PLANNING COMMISSION MEETING
ISD #15 District Office Building 4115 Ambassador Blvd.
Wednesday, May 18, 2022 at 7:00 PM

**RE: Northrup Grumman
Richard D Schroder Advanced Ammunition Site**

We have reviewed the Grading, Drainage & Erosion Control Plan dated April 21, 2022, prepared by Plowe Engineering, and the Stormwater Drainage Report, dated April 21, 2022, prepared by Plowe Engineering for the above-referenced project. We would offer the following:

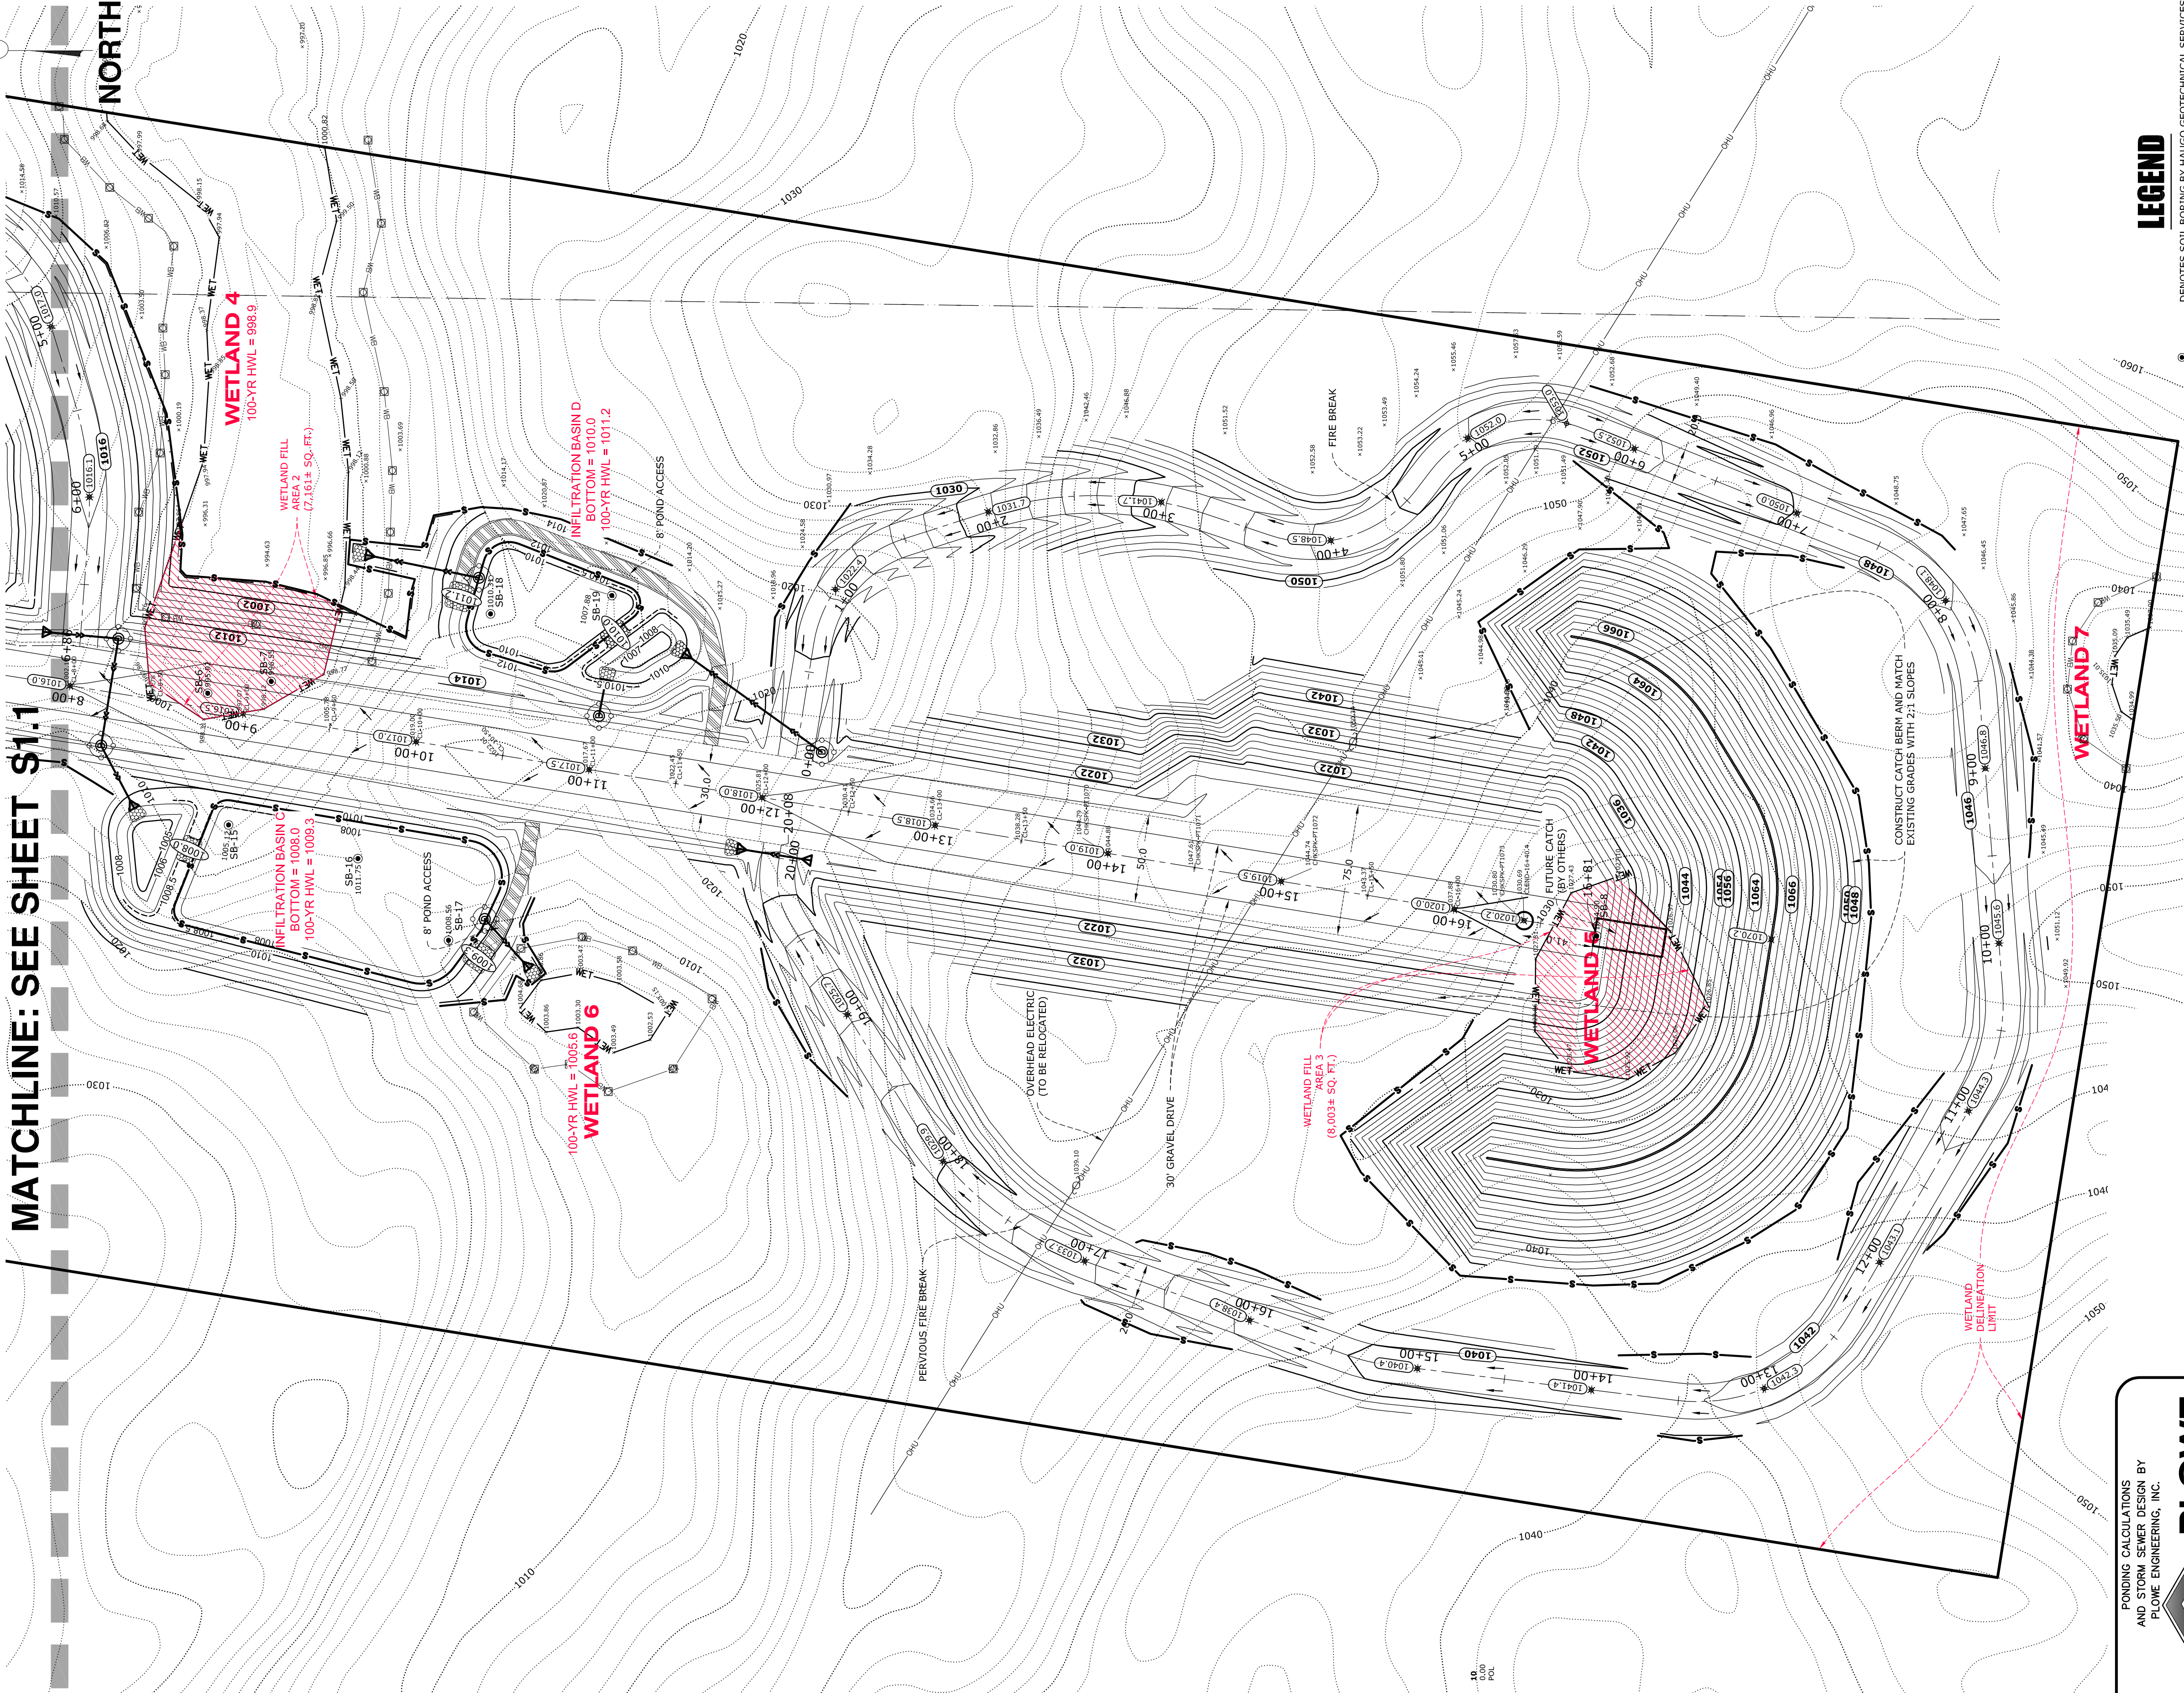
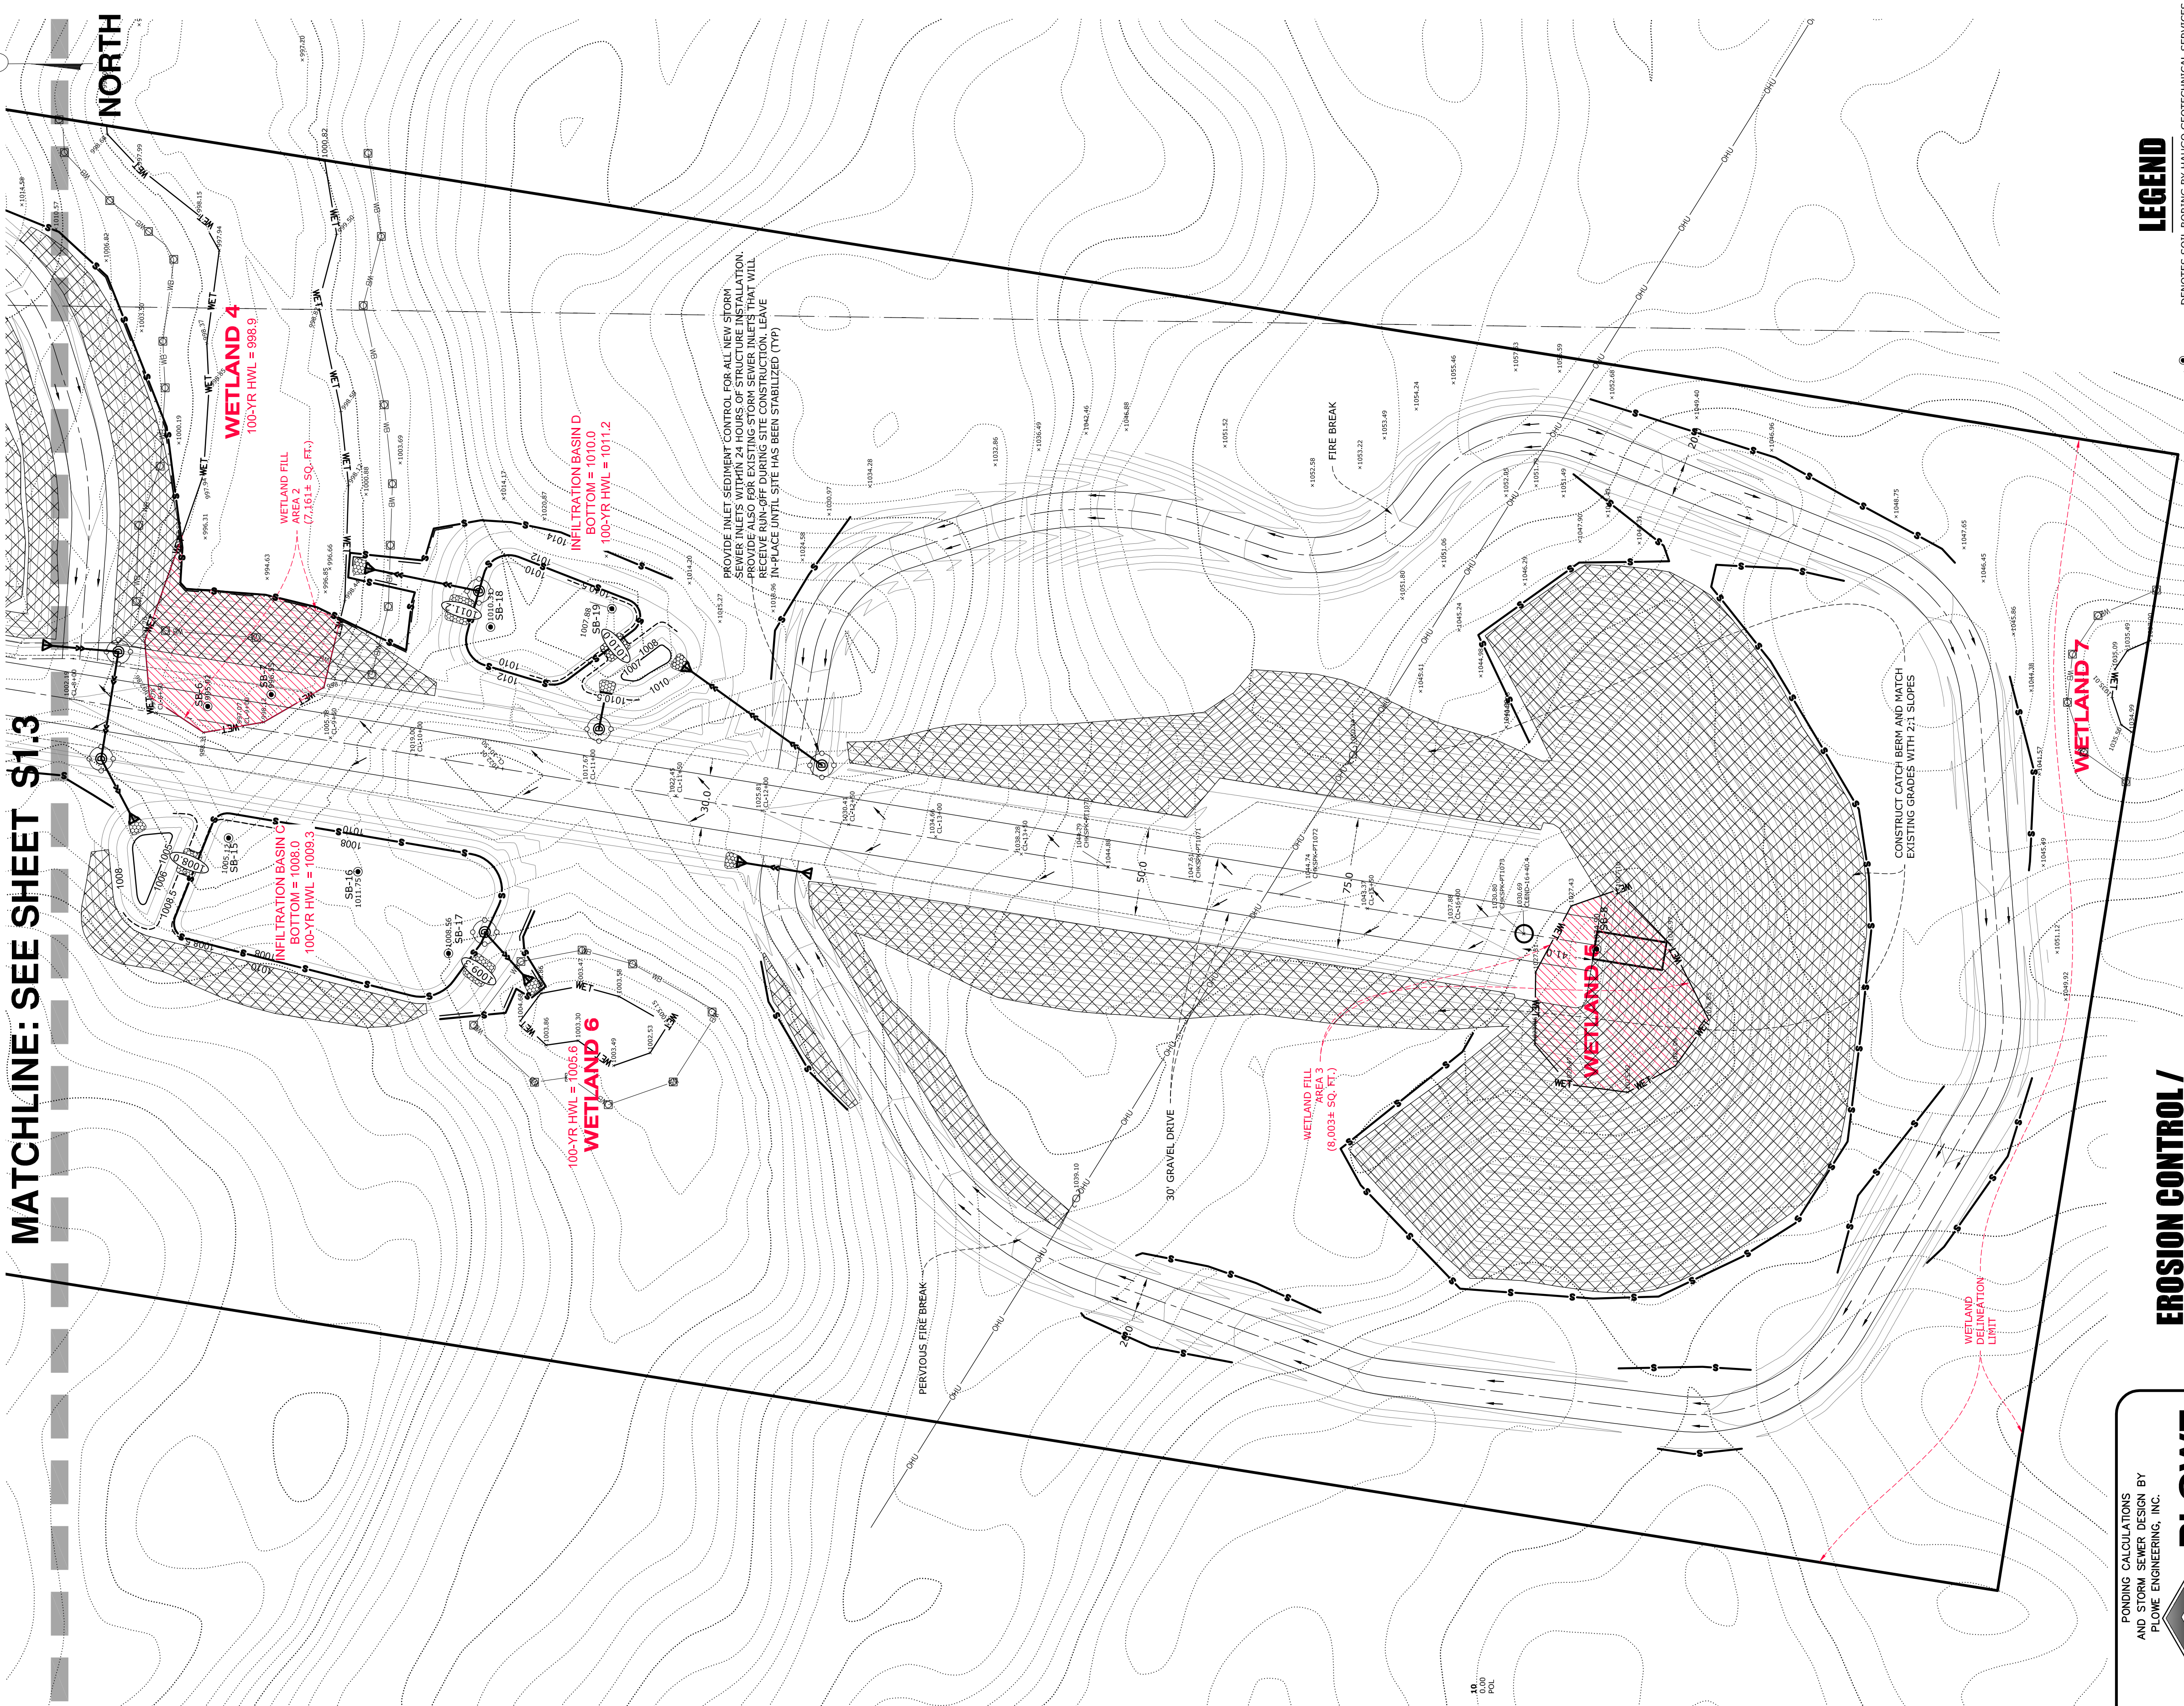
1. The project proposes to fill 21,146 square feet of wetland. A Wetland Replacement Plan has been submitted, however, was found to be incomplete due to required technical components. Any approval is subject to the receipt and approval of a complete Wetland Replacement Plan.

2. Additional silt fence is necessary upgradient of Wetland 6, from station 10+80 to 12+00.
3. Additional silt fence is necessary upgradient of Wetland 7, from station 7+75 to 8+50.

5. The stormwater report shall be revised to include a Pre vs Post summary of stormwater runoff rates for the 2-year, 10-year, and 100-year rainfall events. As per City and URRWMO requirements, the post development runoff rates may not exceed the pre-development rates.

7. The NPDES General Stormwater Permit requires that "Permittees must not use mulch, hydromulch, tackifier, polyacrylamide or similar erosion prevention practices within any portion of the normal wetted perimeter of a temporary or permanent drainage ditch or swale section with a continuous slope of greater than 2 percent". It appears that there are some locations in which the erosion control blanket will have to be extended to include the ditch bottoms. Please revise.
